DX-D 100 DX-D 100 Wireless

SB No. 68

Service Information Bulletin

Replacement instructions for generator batteries

Figure 4: Generator Console

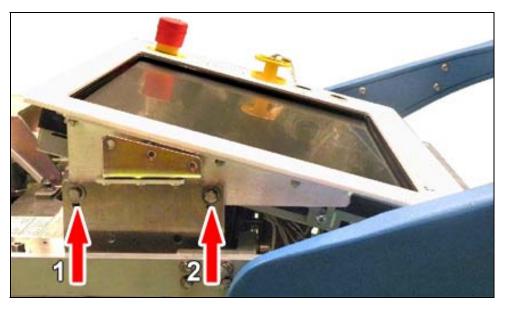
- (1) Switch the generator OFF.
- (2) Press the emergency switch.
- (3)Remove the generator covers (lower back bumper, upper back cover, front cover, console frame) as explained in the Service Manual.
- (4) Loose the four screws at position 1 and position 2 located at both sides of the console (see figure below).
- (5) Lift up the lower end of the console.
- (6)Tighten both screws at position 1 to fix the console in place.

Figure 13: Batteries interconnection harness

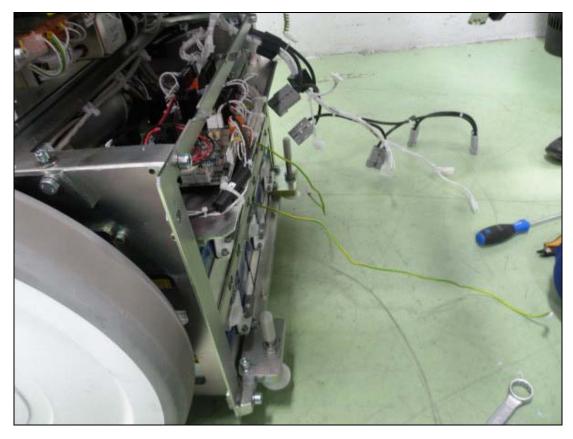
(16) Cut the tie wraps which fix the ground wires with the batteries interconnection harness.

Figure 14: Fixation screws - Metallic frame

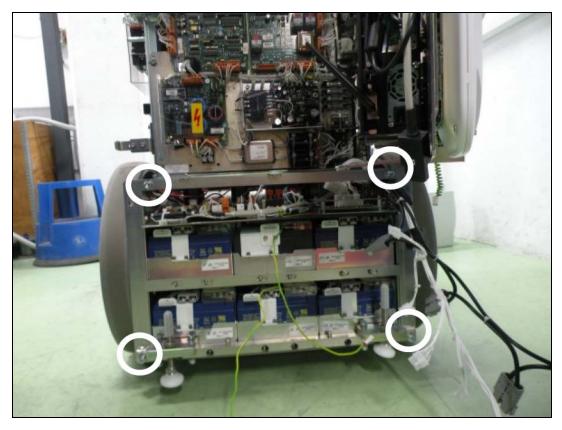
(17) Remove the four fixation screws and dismount the frame that secures the battery trays to the Unit.

Figure 15: Generator Battery Tray (nº3) & Motion Battery Tray (nº6)

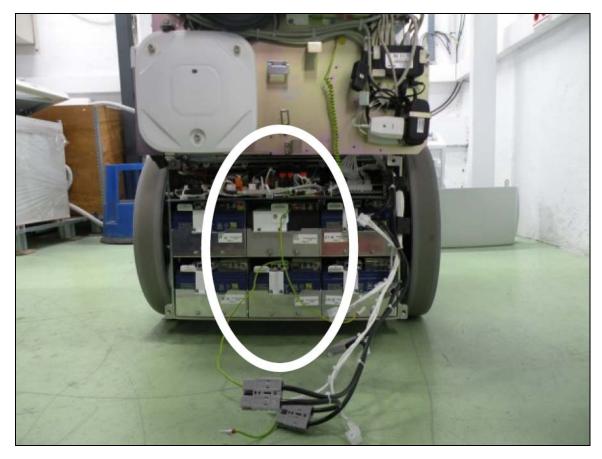
Motion Battery tray will remain in the original position. Generator Battery Tray n^0 3: Install this tray under the Motion Battery tray in the same way as it was mounted originally.

Figure 17: Frame that secures the battery trays to the generator

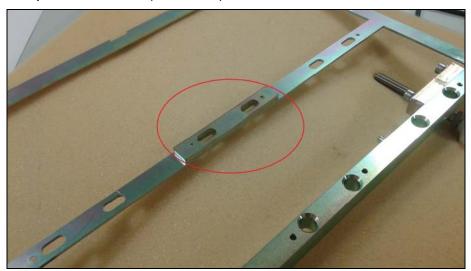
(23) Add part to the frame (see below).

Figure 19: GND wires connection

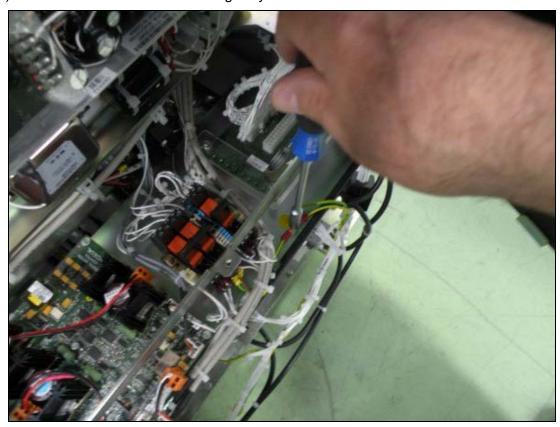
- (25) Mount the frame that secures the battery trays to the Unit:
 - Use 2 screws of the ones removed in step 13 to fix the upper side of the replacement frame to the generator.
 - Use 2 screws M8x40 (see part 'G' in fig 1 replacement kit) to fix the lower side of the replacement frame to the generator.
- (26) Remove the isolation tape from the GND wires.
- (27) Connect both GND wires as originally were.
